**78-10-01 BEECH:** Amendment 39-3210. Applies to Beech Models D18C, D18S, E18S, E18S-9700, G18S, H-18, C-45G, TC-45G, C-45H, TC-45J (SNB-5), JRB-6, 3N, 3M and 3NM modified in accordance with STC SA1243WE, SA1016WE, or SA360WE.

To preclude failure of the lower rudder torque tube, accomplish the following; unless already accomplished:

DOCKET NO. 78-WE-4-AD

AD 78-10-01

FIGURE 1

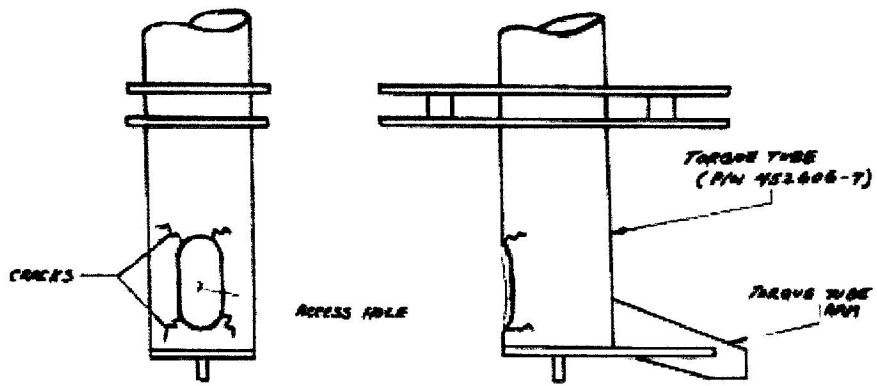
(a) Within the next 30 days after the effective date of this AD visually inspect the lower rudder torque tube for cracks in the area of the access hole as noted in figure 1 of this AD. (Reference Part Number 452606-7).

(c) If cracks are found, prior to further flight:

(1) If any crack exceeds 1/2 inch in length, replace with a like serviceable unit, Part Number 452606-7, and reinspect per paragraph (d);

(2) If cracks are 1/2 inch or less in length, repair per a method approved by the Chief, Aircraft Engineering Division, FAA Western Region, and reinspect per paragraph (d);

(b) If no cracks are found, reinspect at intervals not to exceed 30 days from the prior inspection.

(d) Reinspect at intervals not to exceed 30 days from repair, replacement, or prior inspection.
